Sufism Reoriented

**Re: Limited Appeal Of Conditions
New Sanctuary For Sufism Reoriented
County File Nos. LP08-2034 and MS09-0008**

Appeal by the Saranap Homeowners Organization of the Contra Costa County Planning Commission FEIR Certification and Approval of Sufism Reoriented Land Use Permit and Minor Subdivision – County Files LP08-2034 and MS09-0008 on November 8, 2011.

**Appeal of the Sufism Reoriented Land Use Permit and Minor Subdivision
LP08-2034 and MS09-0008**

grasspave2 after initial truck entry

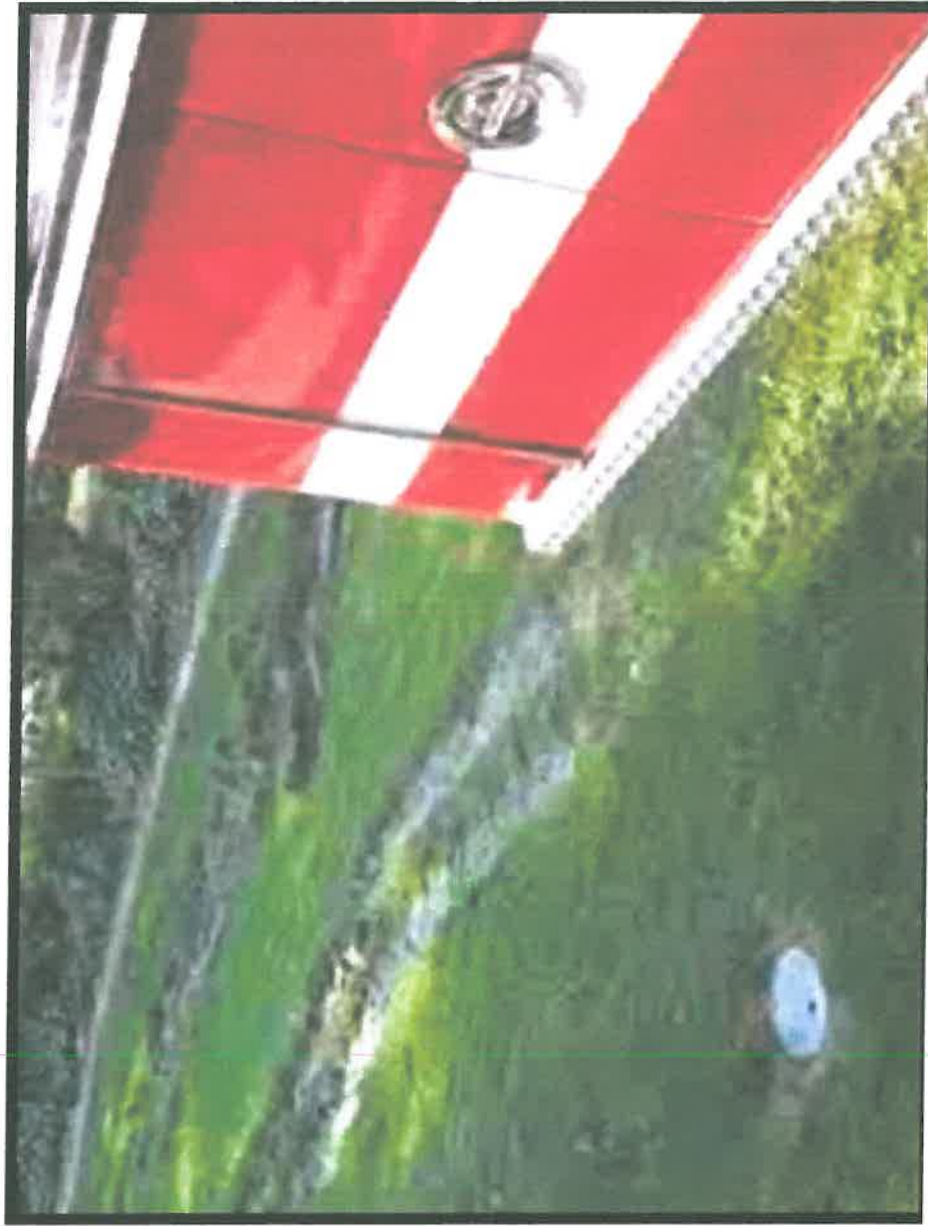
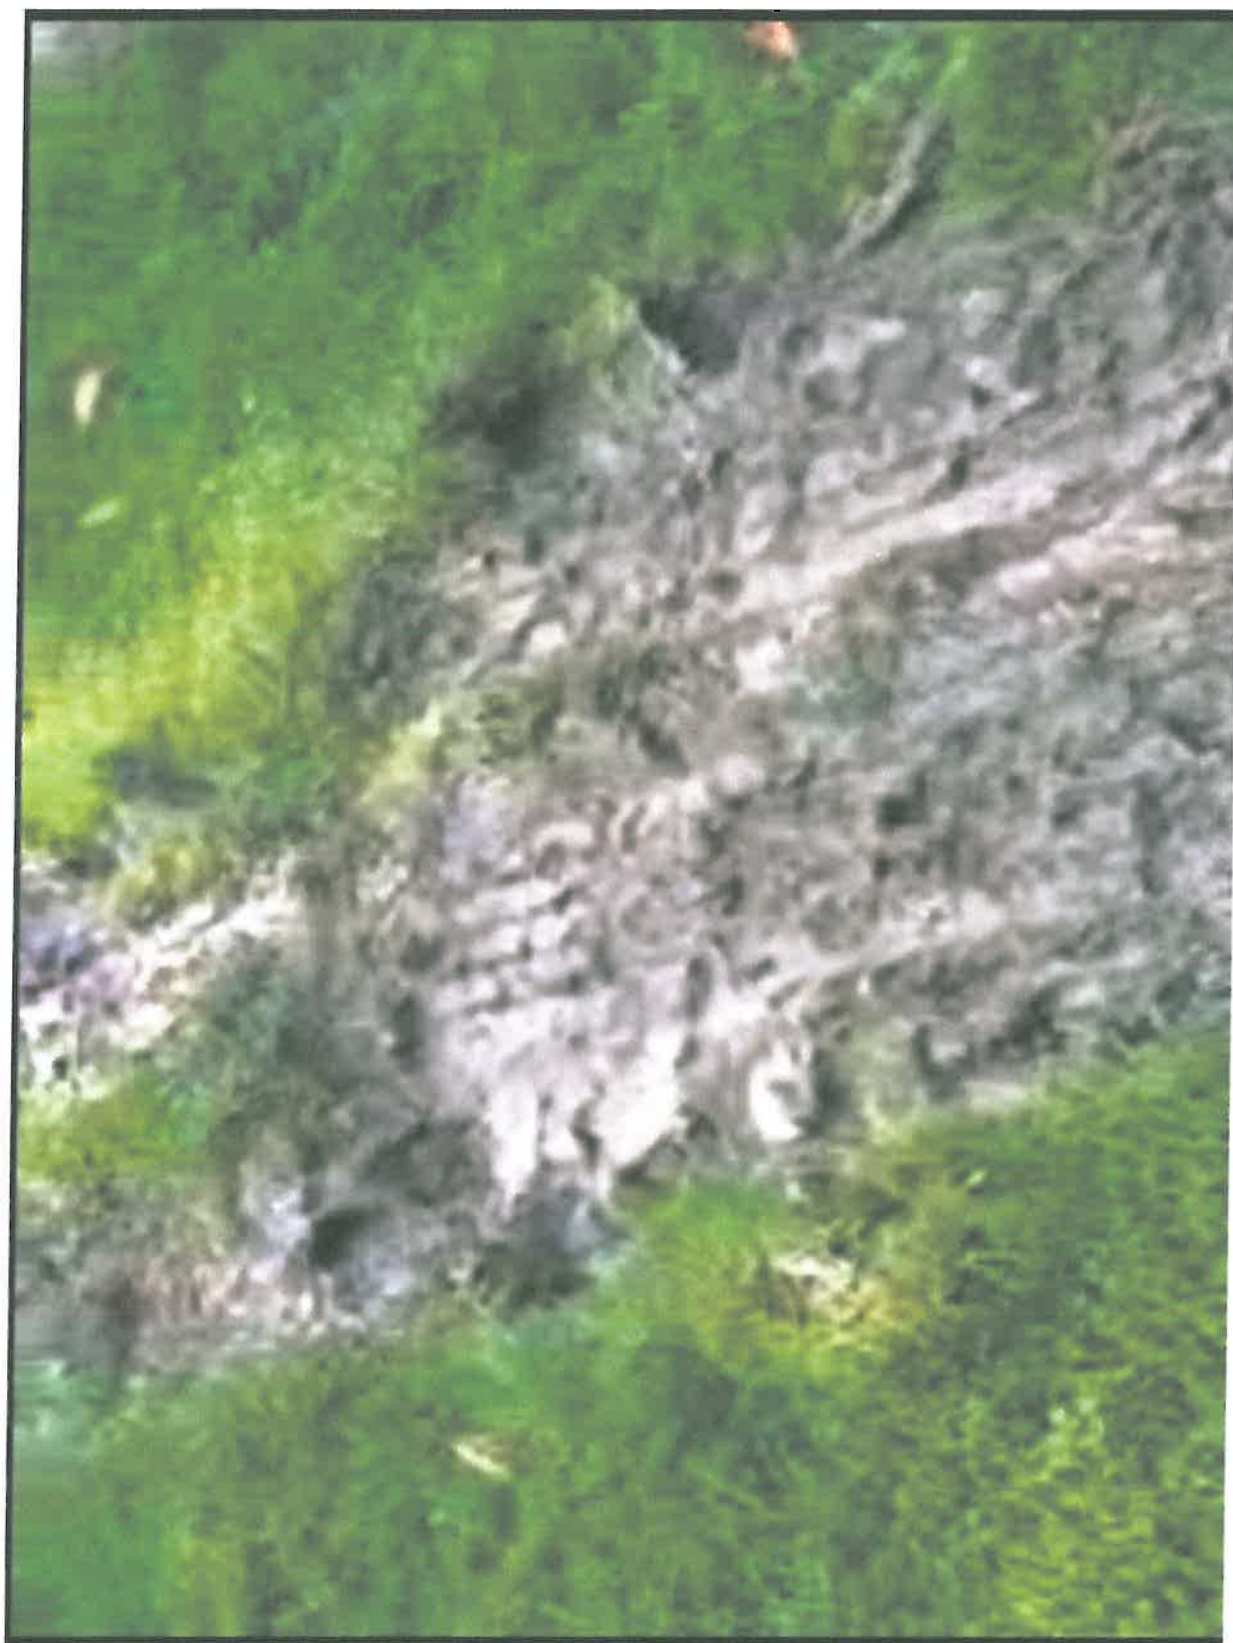
Further, review of the detailed project plans indicates not only that some of the EVA routes may not allow sufficiently close approach to the sanctuary building to provide effective fire access, but that portions of the routing would be over "grasspave2", permeable paving system that involves layers of sand and gravel, planted with grass. (Project Plans, p.4.4.) I am submitting with this letter several photographs from a test of driving a Contra Costa Fire Protection District fire truck over grasspave2 (at a site in Pleasant Hill) showing extensive rutting that could make the driveway impassible upon multiple use¹. At the very least, use of grasspave2 could result in an unsightly mess after even a single call for service. Who would be responsible for repairing the damage is unclear, but it could well be the County. It is not apparent whether the fire district personnel who reviewed the project plans are aware of the potential consequences of using grasspave2 on EVA routes for this project.
